December 2015 (ILT 2015) Initial License Examination

FIGURE 09.1- 2
IN-Core Instrumentation Location Diagram

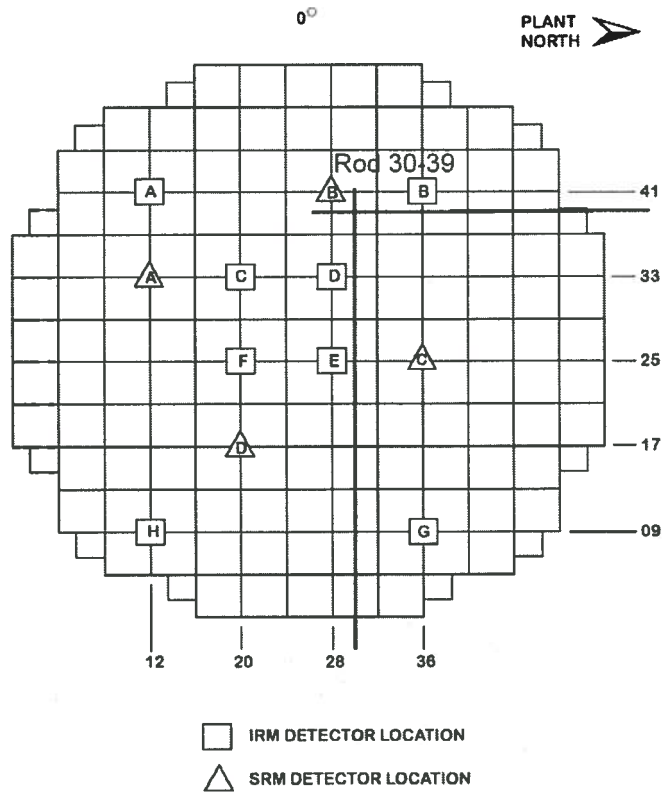
In accordance with NUREG-1021, Operator Licensing Examination Standards for Power Reactors, ES-403, Section D.1.b, the wrong answer being selected on the answer key, the **facility recommends that the correct answer be changed from 'D' to 'C'.**

Part 2 of the question identifies the wrong SRM Channel. It is the B SRM detector, instead of C. The validation of the question did not identify this error.
